1 Rosser Street

**RE: 1 Rosser Street, Cottesloe**

# REVISED PLANS

PROJECT  
**PROPOSED GARAGE AND SHED**

TITLE  
 DECK LEVEL PLAN - SETBACKS

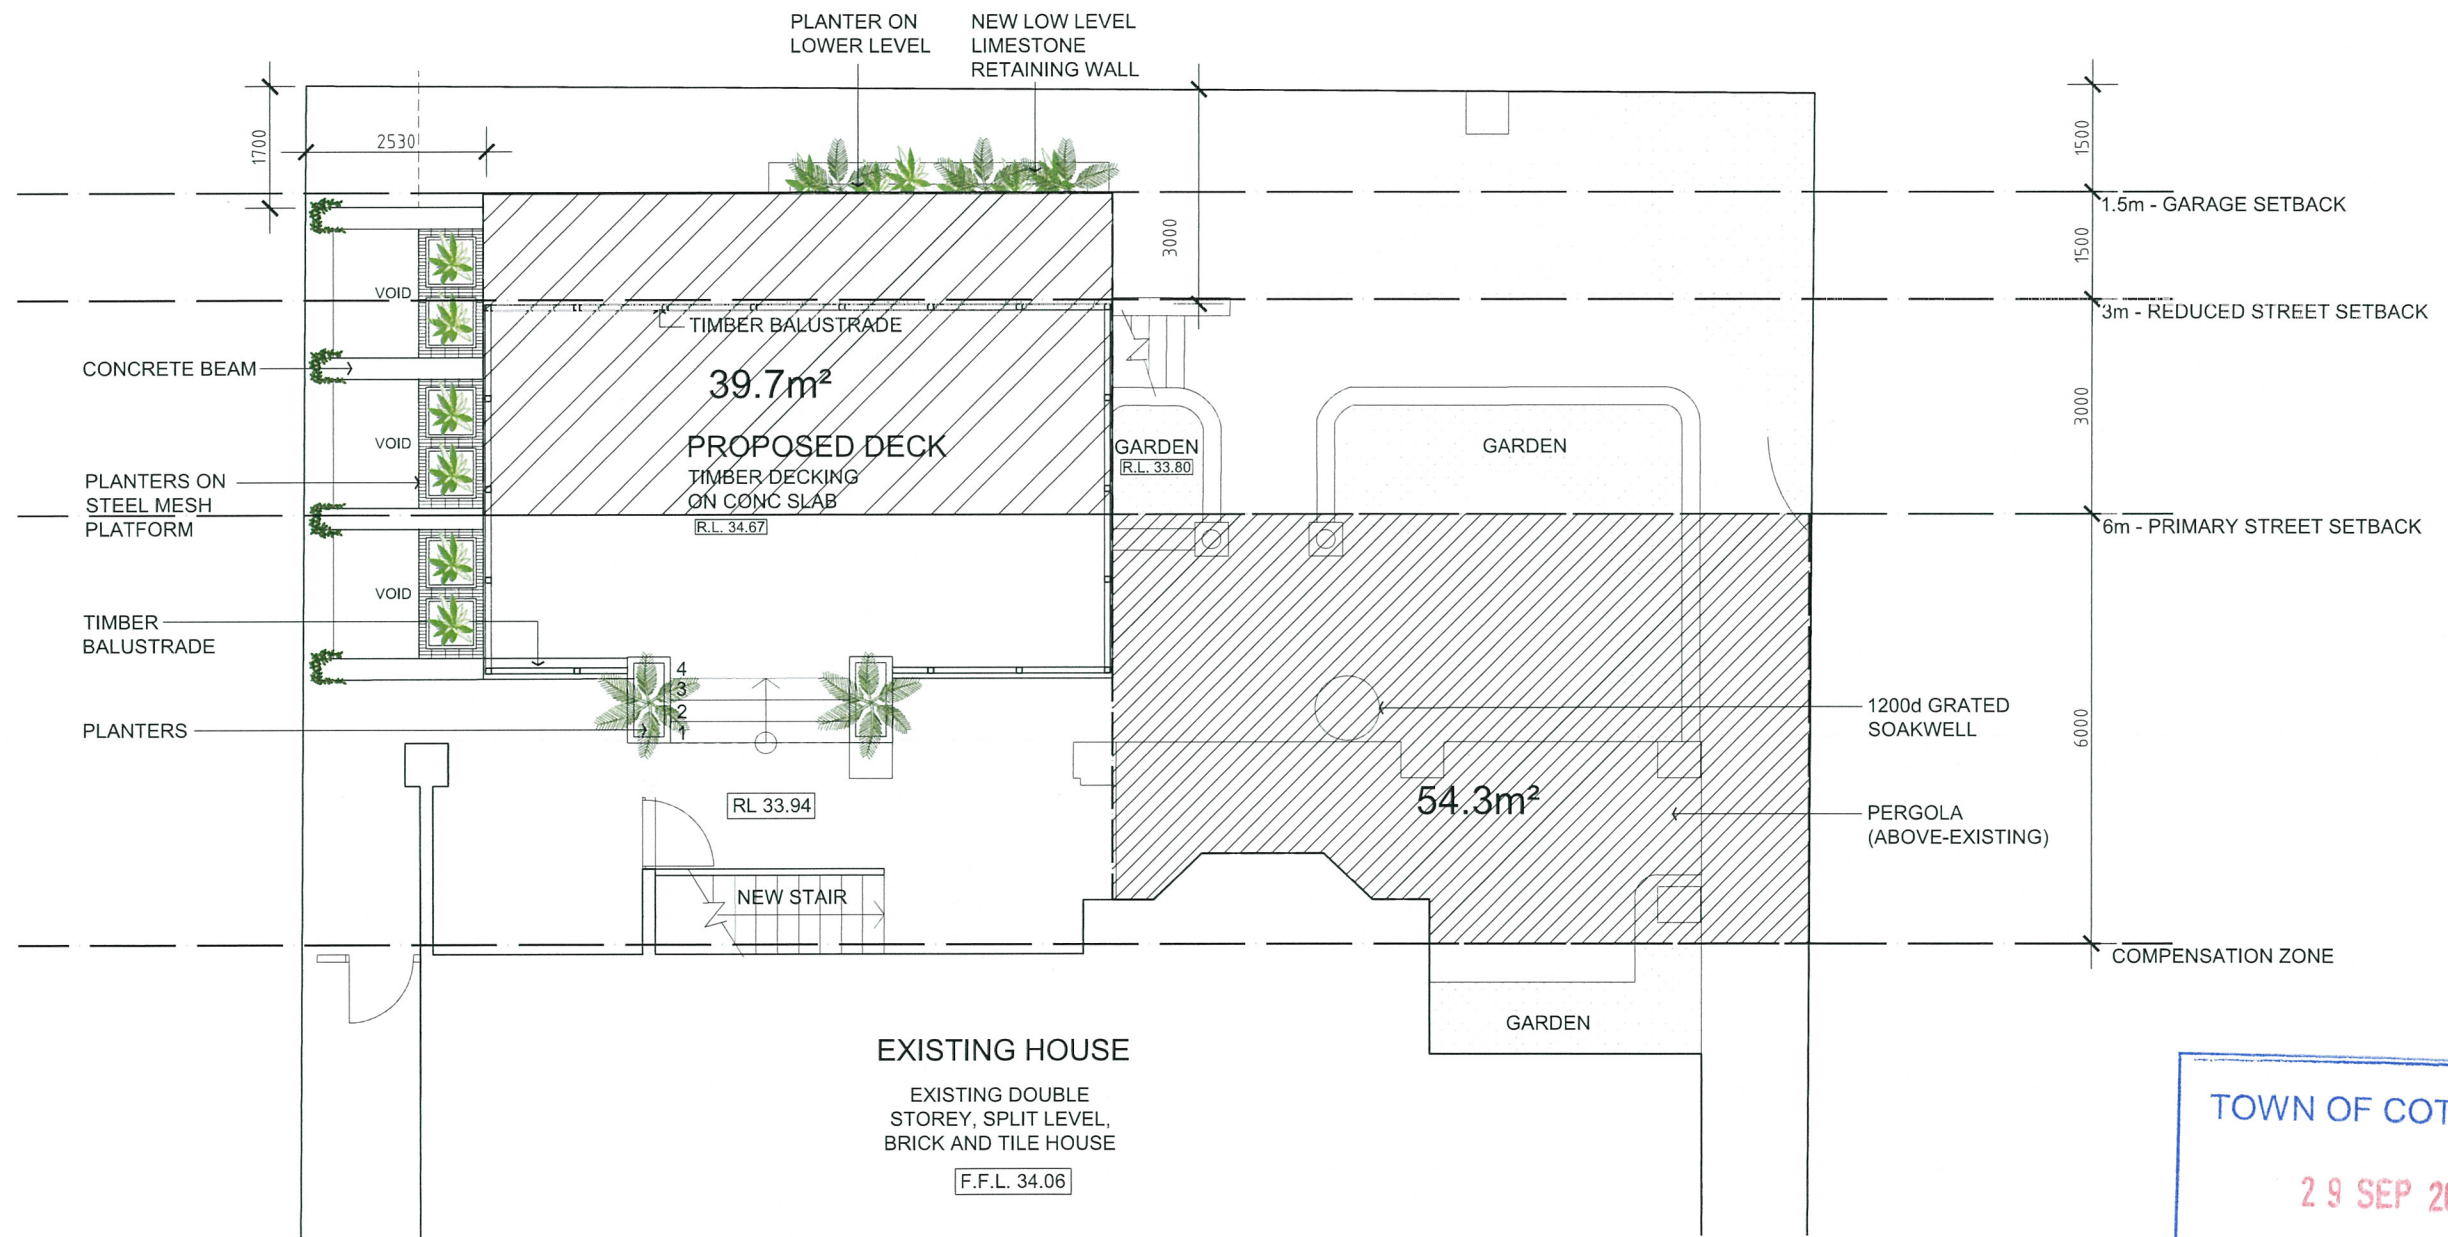
- We have also included an additional sketch reflecting our interpretation of the R. Codes relative to the averaging of front setbacks. This demonstrates our belief that the proposal would in fact be compliant under the R Codes deemed to satisfy parameters. If that is the case, it would reduce the perceived negativity of technical non-compliance, as concessions would not be required.

# ATTACHMENT 2 SETBACKS

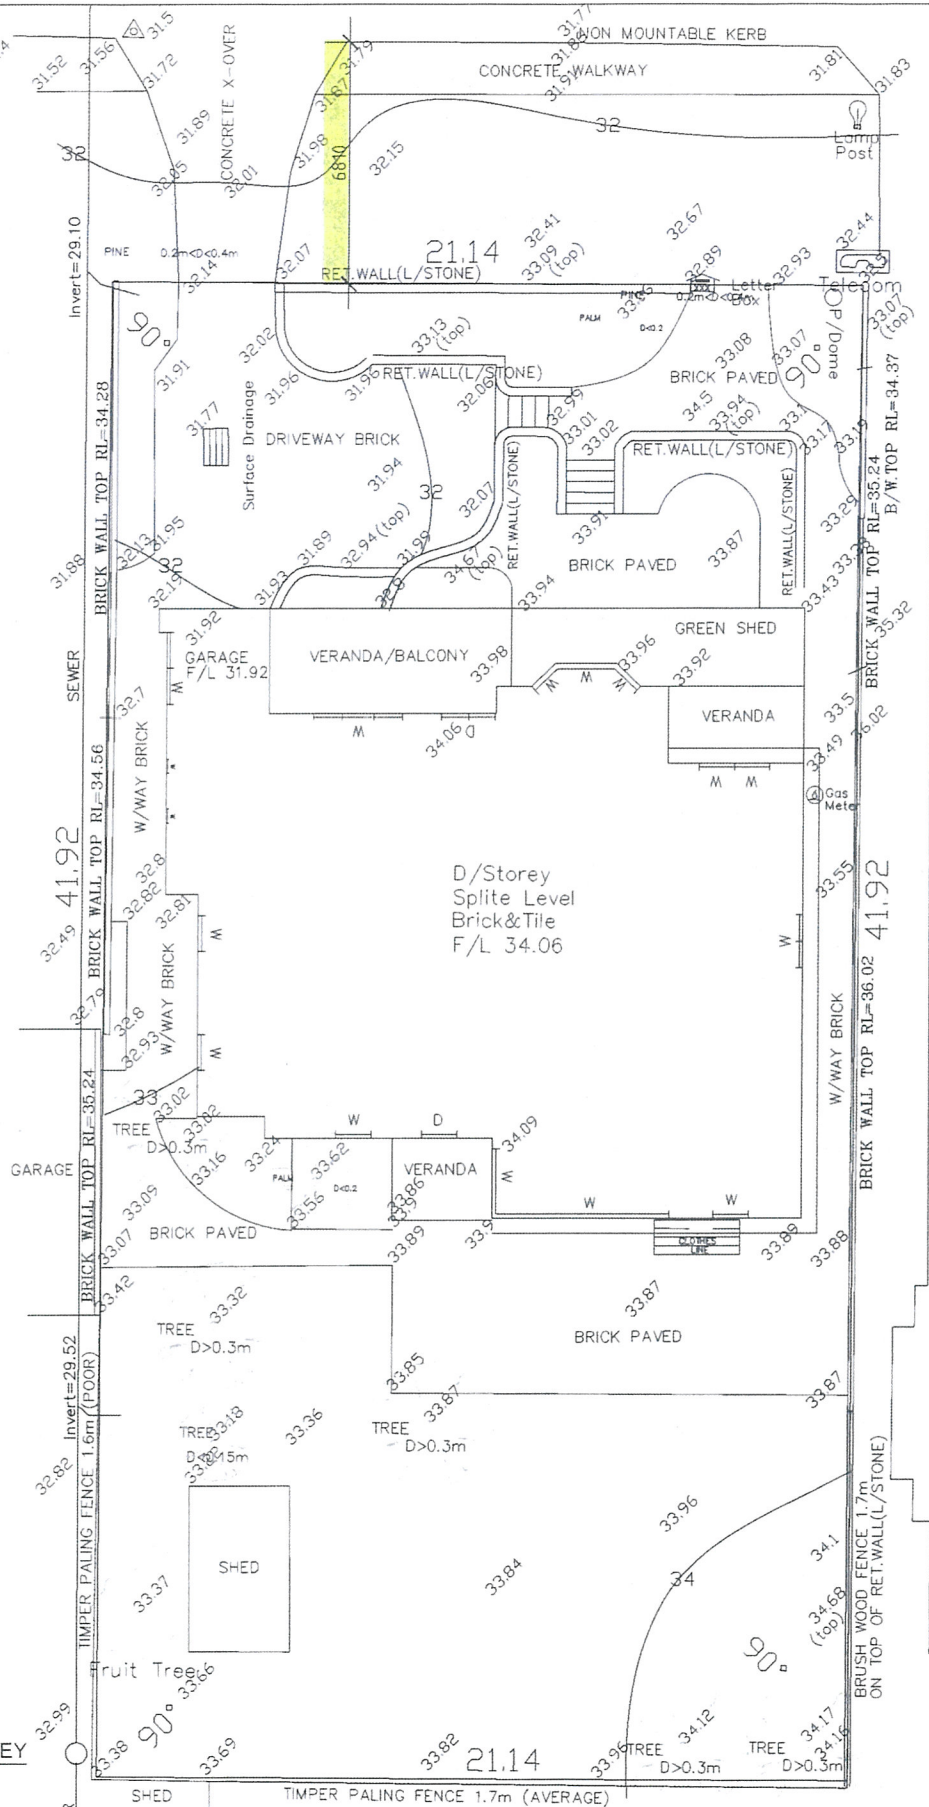
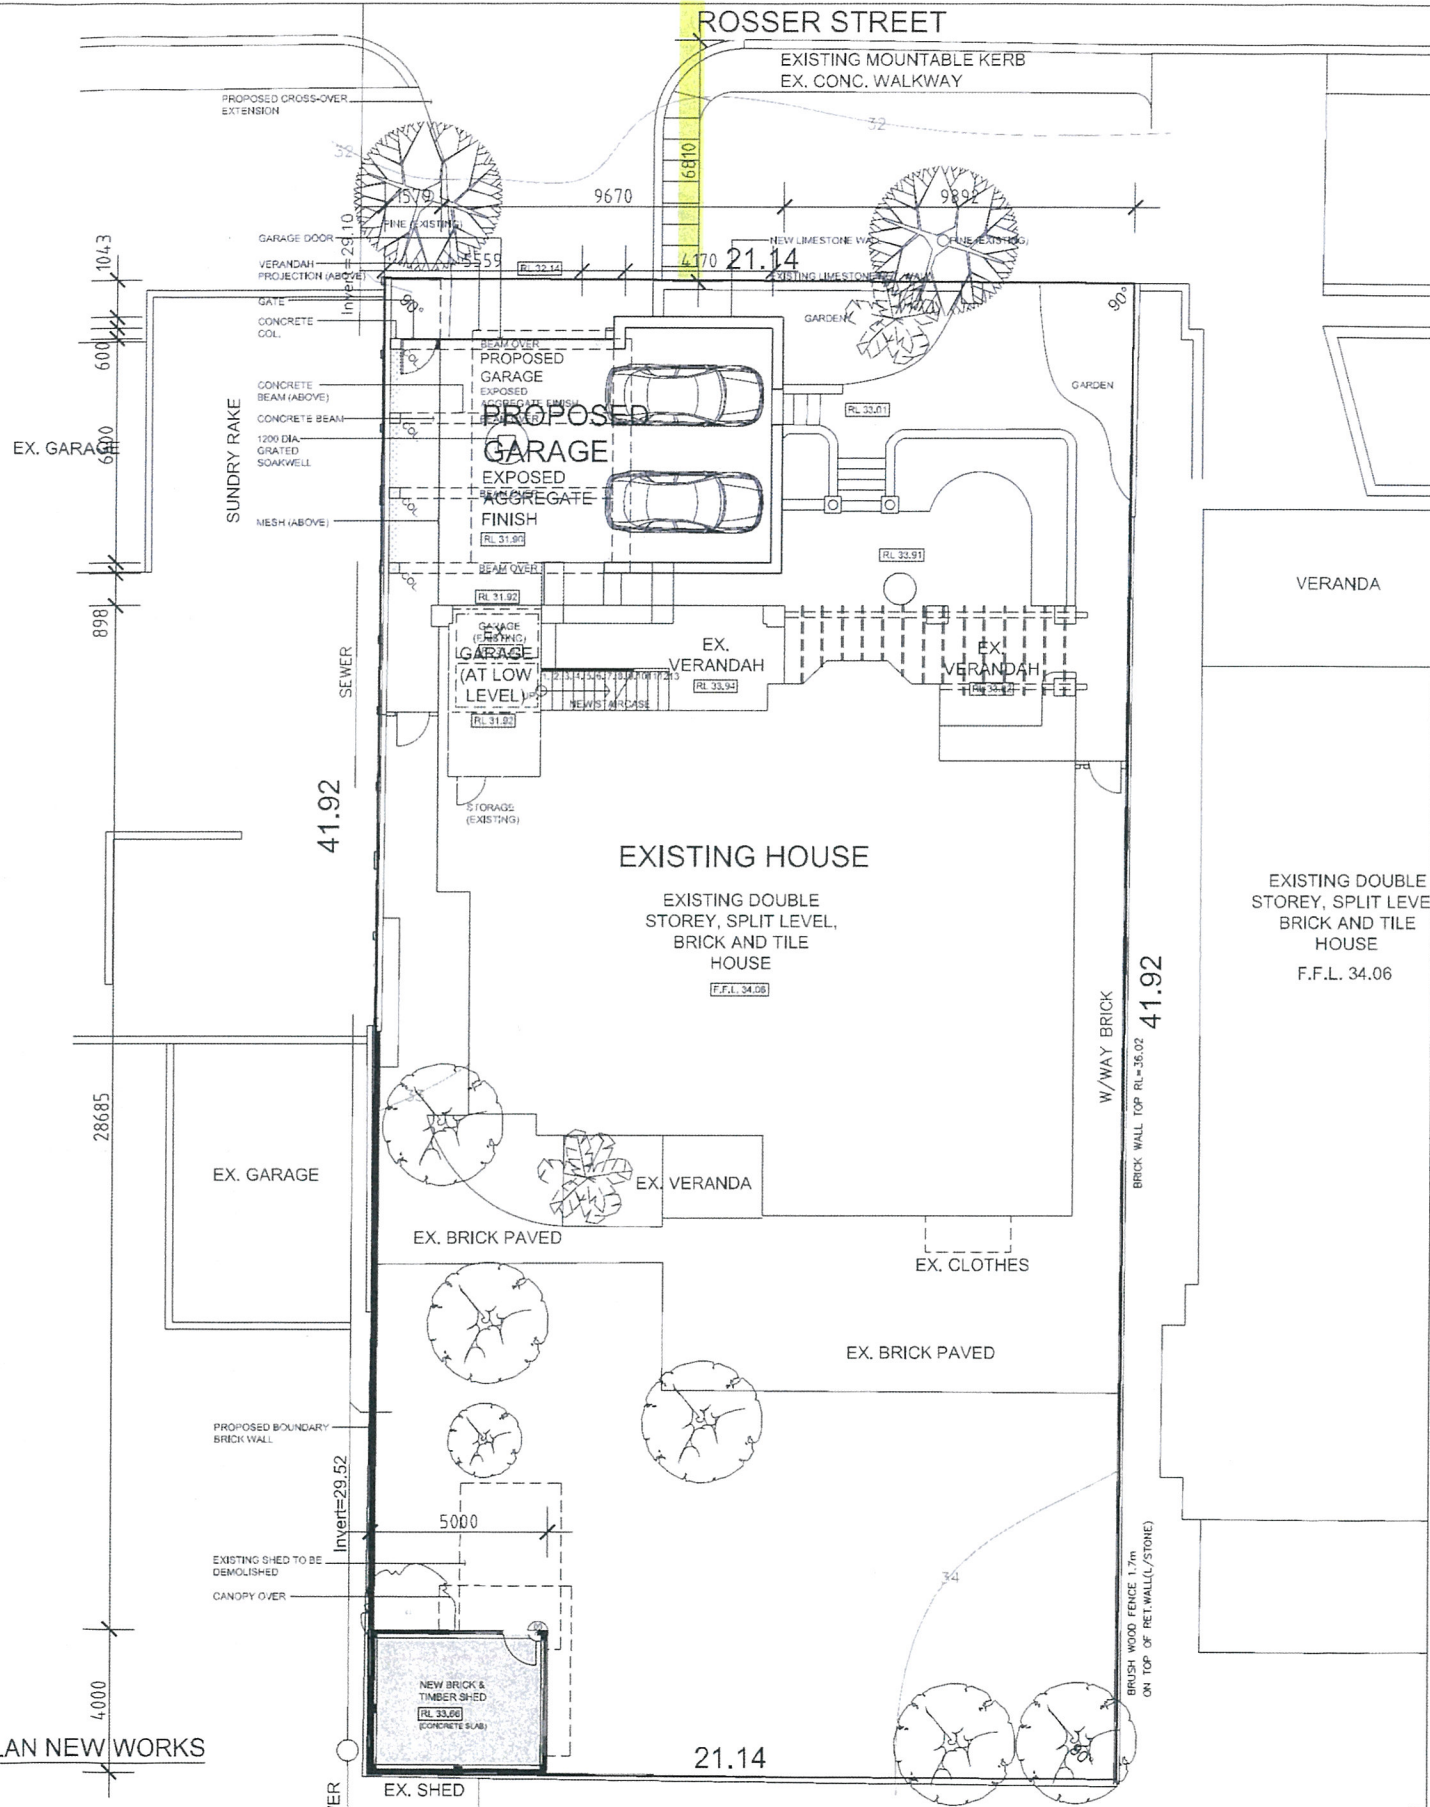
- *The proposed garage/deck does not satisfy the front setback requirements of the RCD.*
- *The average and minimum setbacks for a garage of 4.5m from the front boundary are not achieved.*

As per the survey, the existing house (including verandahs) is setback off the boundary by 7.94 metres. (Attachment 2 – Survey Plan). As we were not at liberty to develop a standard garage perpendicular to the street boundary and due to the construction methodology used for the existing house (limestone base), the garage has been located as far away from the boundary as possible. However it is worth noting that there are numerous examples of built form being accepted by council (for various reasons) that have a far greater impact on the streetscape than what is being proposed. This includes garages that have been located anywhere between zero metres and 1.7 metres from the front set back (refer Attachments 6, 7 & 8). In fact a recent example shows an entire two storey house built over the entire frontage set back only 1.5 metres from the street boundary (see image of 1 Princes' Street in Attachment 7).

1 NORTH ELEVATION  
SCALE: 1:100

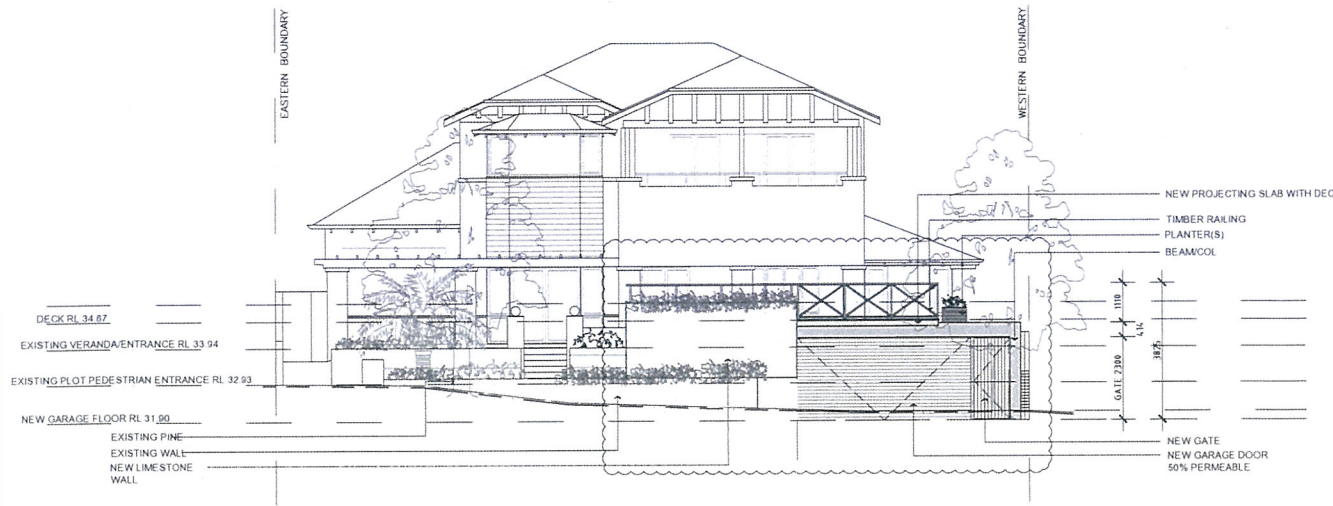
- *The wall facing the street (north elevation eastern side) that extends above the balustrade rails (western side). Can this be made lower to match the balustrade shown on the western side of this elevation?*

This north facing wall is already below the height of the balustrade and will be further softened by foliage cascading down the front and plantings growing up the face from below.

TITLE  
 STREET ELEVATION  
 (DIAGRAM)

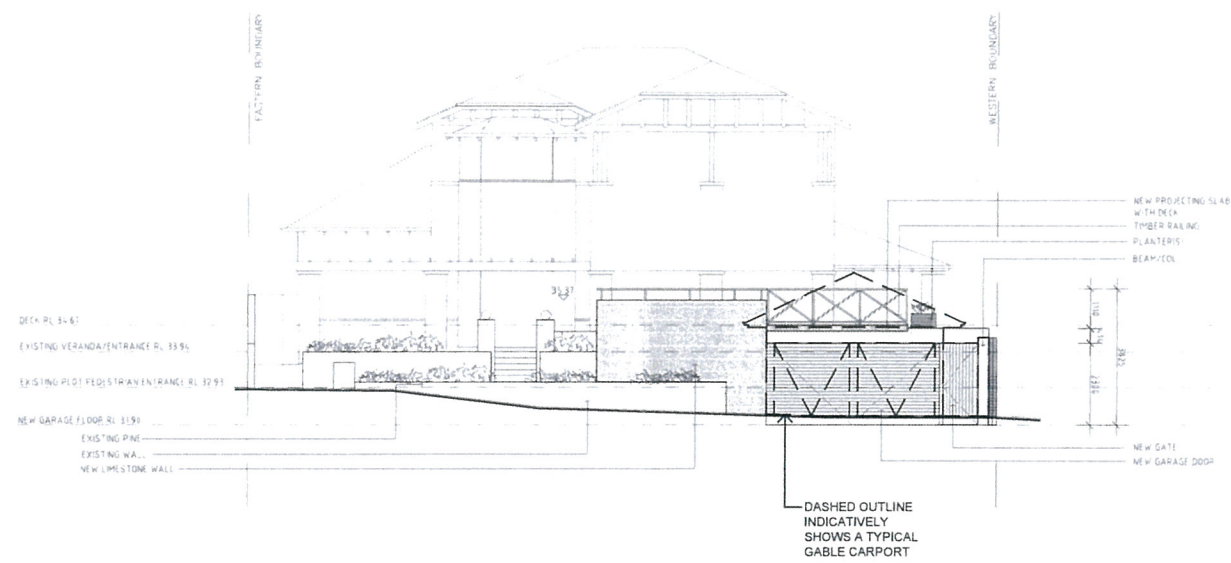
Additionally, we enclose a very basic sketch indicating the scale of a standard gable roofed carport which is in our opinion far more dominant in its massing and relationship to the streetscape.
